In Reply Refer To: HSST/CC-115I

Name of system: Trinity Soft-Stop Anchor Plate Modification

Type of system: W-Beam Guardrail Terminal

RE: Proposed Changes to Soft Stop Anchor Paddle

Figure 4. Data from Static Tests S1, S2, and S17.

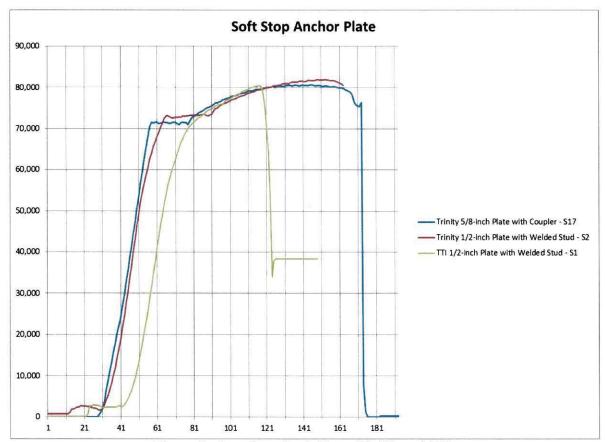
The original ½-inch thick anchor plate and welded rod had an ultimate load of approximately 80 kips at failure. Any of the 1½-inch threaded couplers used in conjunction with 5%-inch plate and 3/4-inch ASTM A193 B7 threaded rod generated approximately the same peak loads and would be acceptable substitutes for the original anchor plate and welded rod. The graph for this information is shown below.

Scale 1:30 Sheet 1 of 1 Paddle Versions

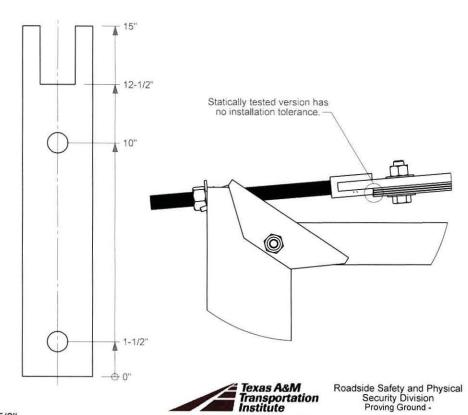
Our Construction Section identified a low tolerance issue on the recently tested (static) Soft Stop Anchor Paddle (TTI510602-SSM S1-S3 and S15-17) Contract #'s P2013207 and P2013361. The coupler is embedded 2.5 inches into the 5/8 inch plate where the original welded stud was only embedded 2.0 inches. When the w-beam is attached to the Soft Stop Anchor Paddle, the clearance between the end of the w-beam plate sections and the back of the coupler is almost zero. By increasing the distance between the back of the coupler and hole in the 5/8 inch plate to 2.5 inches, this tolerance is made acceptable. This moves the bottom hole closer to the end of the Anchor Paddle Plate, however, this hole is the non-critical connection point. The upper hole must fail in conjunction with this hole for the w-beam to release from the Anchor Plate. Therefore we submit the attached drawing for your consideration as installation is enhanced and performance is not degraded.

Statically Tested Version Ref: Tests 510602/SSM S1-S3 and S15 - S17

Proposed Version for Production

Plate, 3" x 5/8" ASTM A572 Gr. 50 Both Versions
